New design DMX PCB

The DMX Interface PCB (62021000) we have been using for the past 12 years has been redesigned for the current market.
It is now a DIGITAL PCB with the ability to change the software using the Epsilon Programmer.
It has been designed as a DIRECT REPLACEMENT in units such as the ZR33, Magnum Club Smoke, AF1 MkI, Magnum 2000 DMX interface, ZR12 DMX interface etc..
It is the same footprint and mounting points BUT the connectors have changed location.
Please refer to the label on the antistatic bag the PCB is supplied in and the photos below:

6202 1000
** NB **
New Version
PL1. -ve, +ve
& Output.
PL 2.
Dmx Input.
DMX Receiver
Mega 48. Jem.
ZR 33 etc.
ROHS

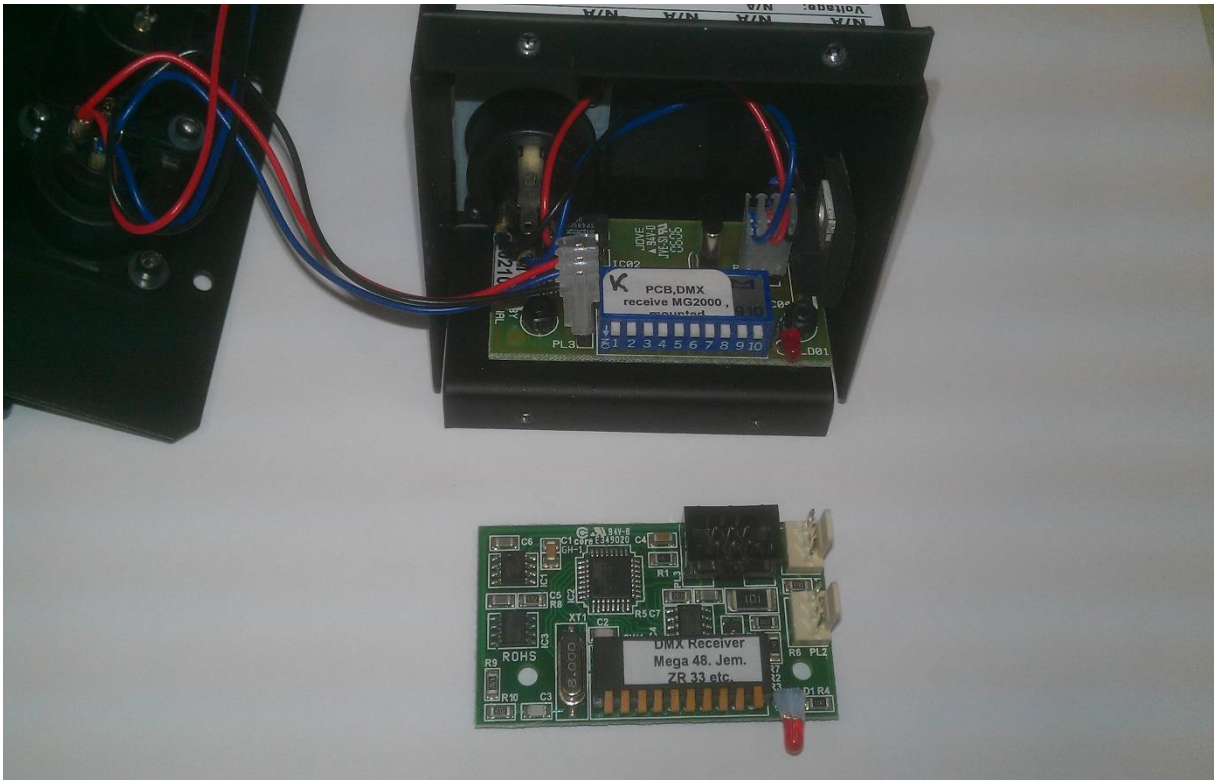
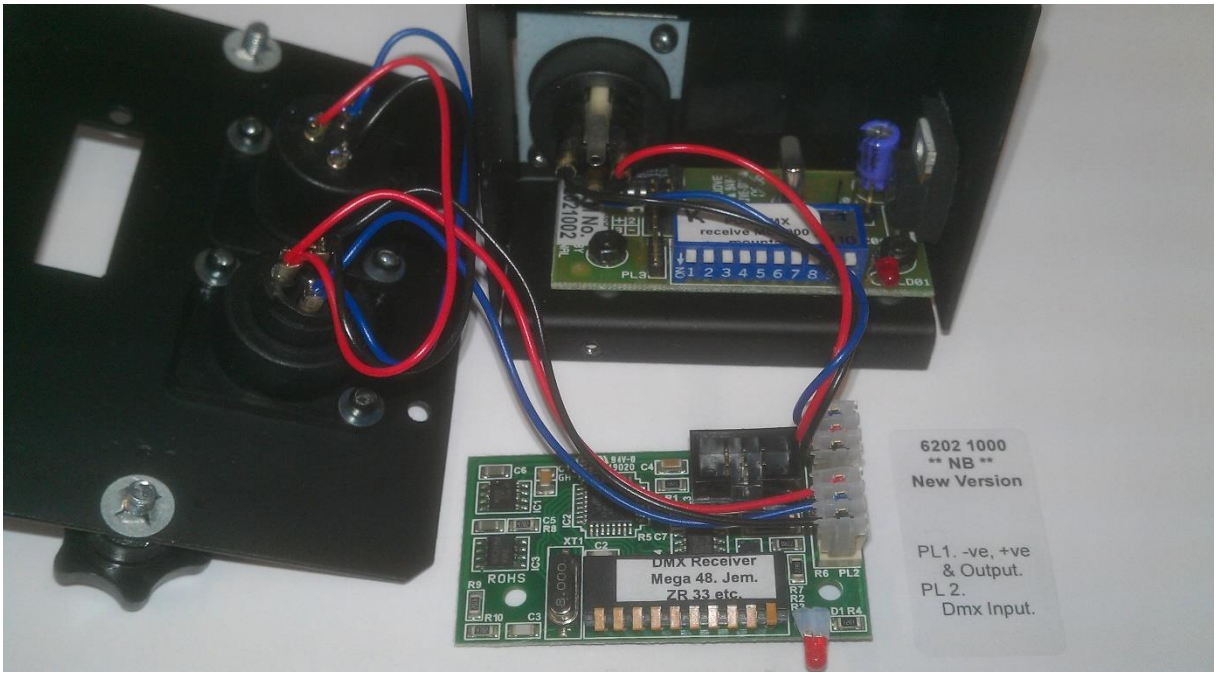
PL3 moves to PL2.

PL05 goes to PL1.
